3.7 - LIMITING CONDITIONS FOR OPERATIONK. Suppression Chamber

Attachment B
Revised UFSAR and Technical Specification Bases Pages

Affected Updated Final Safety Analyses Report Pages

DRESDEN — UFSAR

Table 6.3-18

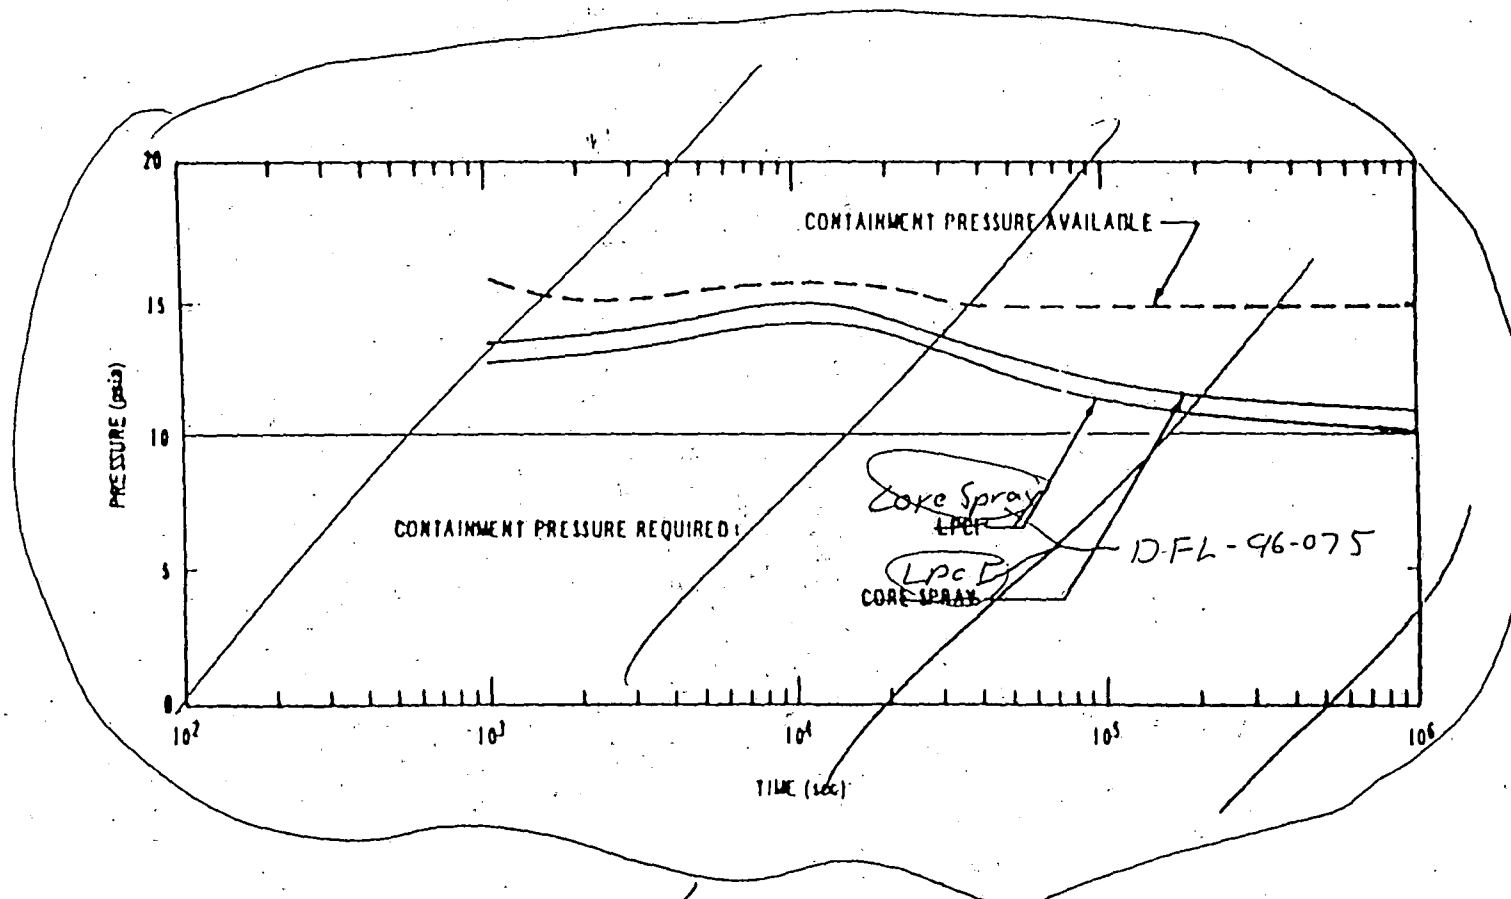
(Delete)

< Delete >
